SUBJECT: Addendum No. 3
Calhoun-Charleston Utility District
Highway 163 Waterline Extension

ADDENDUM NO. 3

HIGHWAY 163 WATERLINE EXTENSION

1" AIR RELEASE VALVE DETAIL
NOT TO SCALE

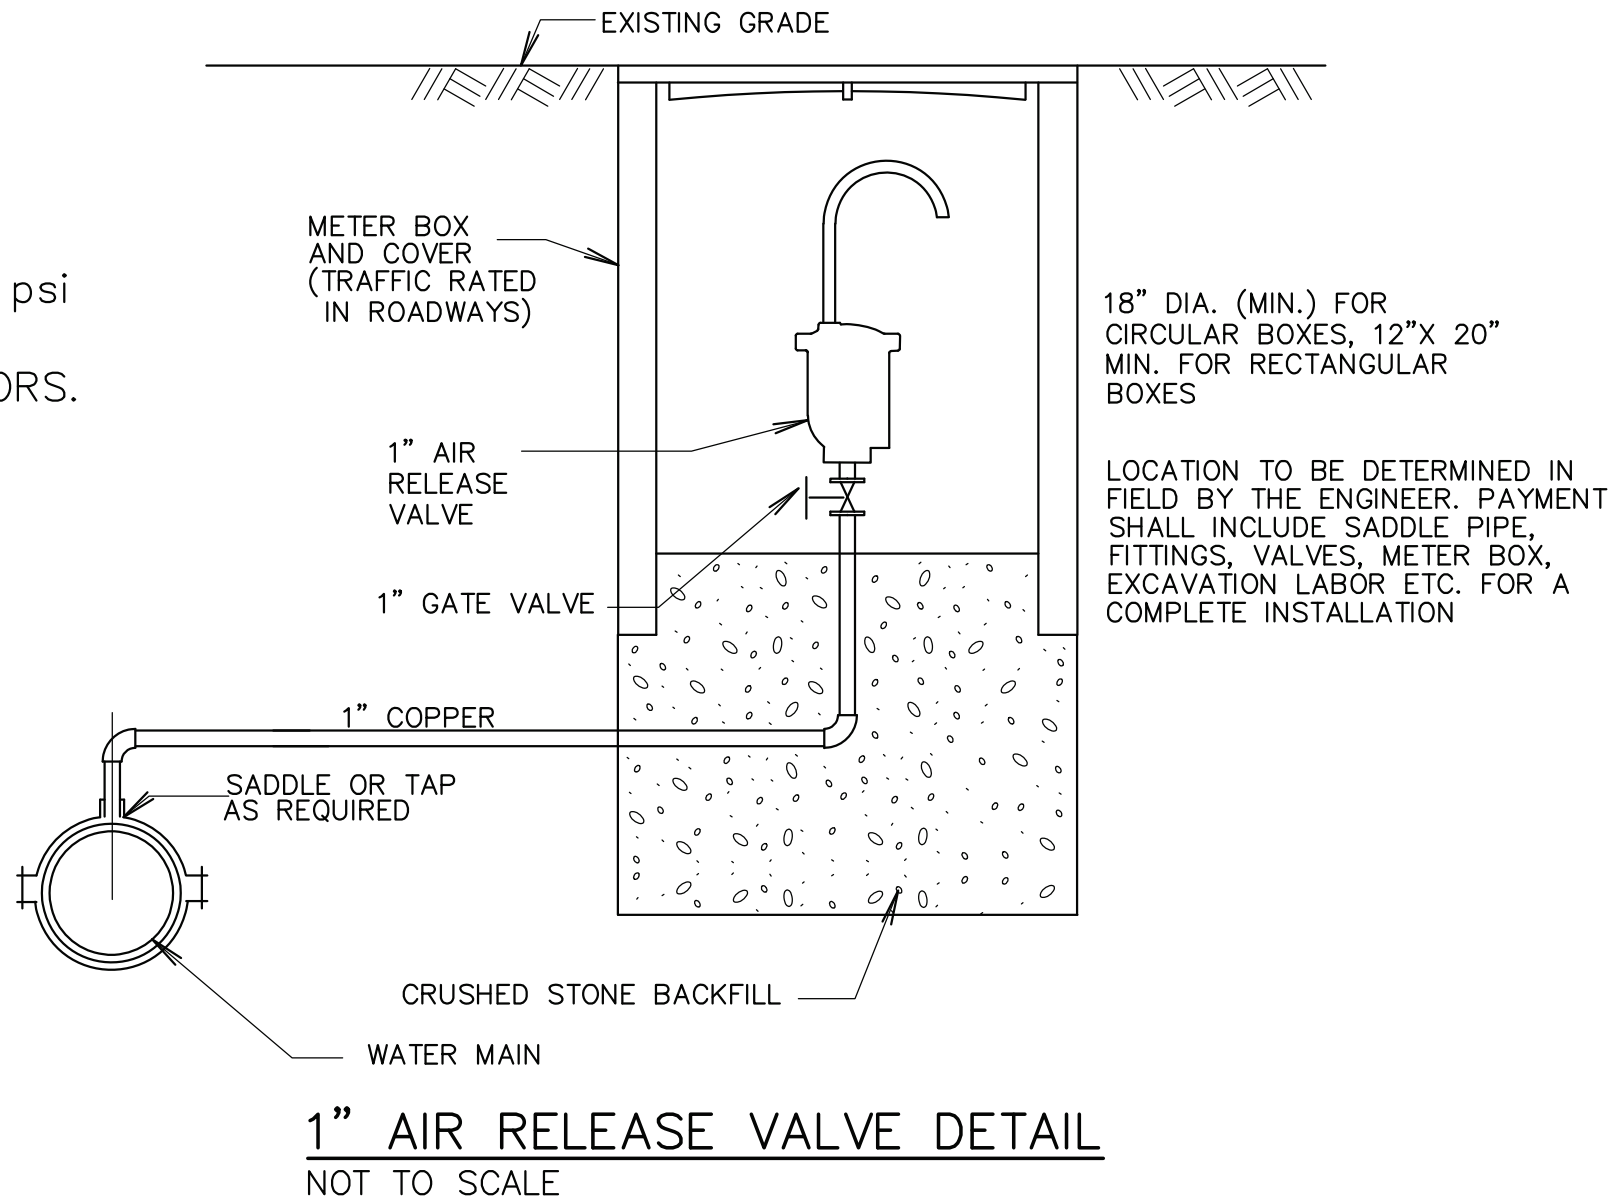
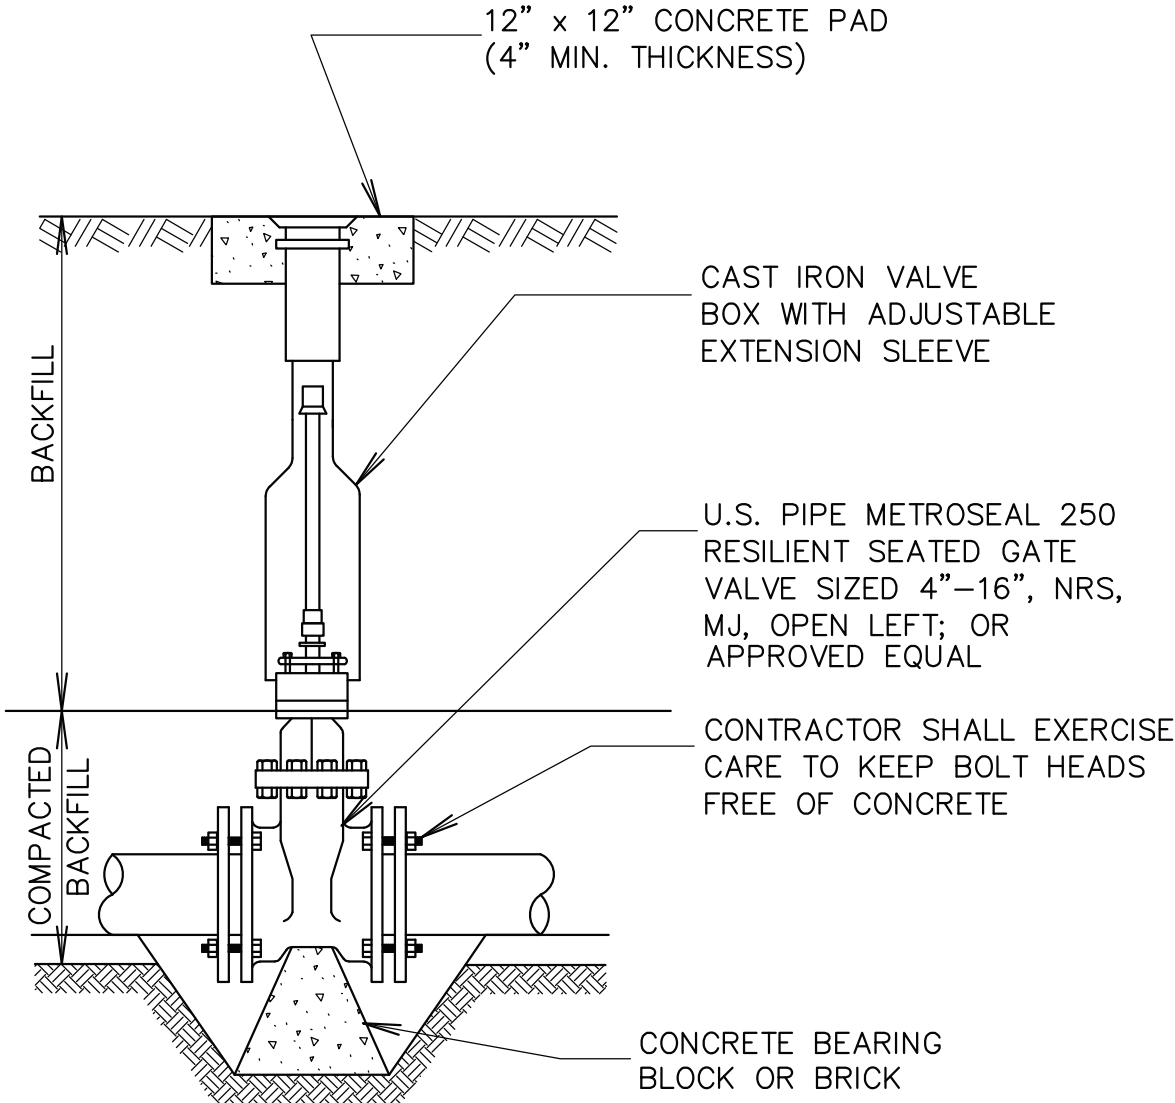
- A.** The 1-inch air release valve shown on the Contract Drawings may be either APCO or A.R.I. Both are acceptable for this project. The specified 0-150 psi working pressure range shall not preclude the use of an APCO valve having a published working pressure range of 11-150 psi or an A.R.I. valve having a published working pressure range suitable for the application.
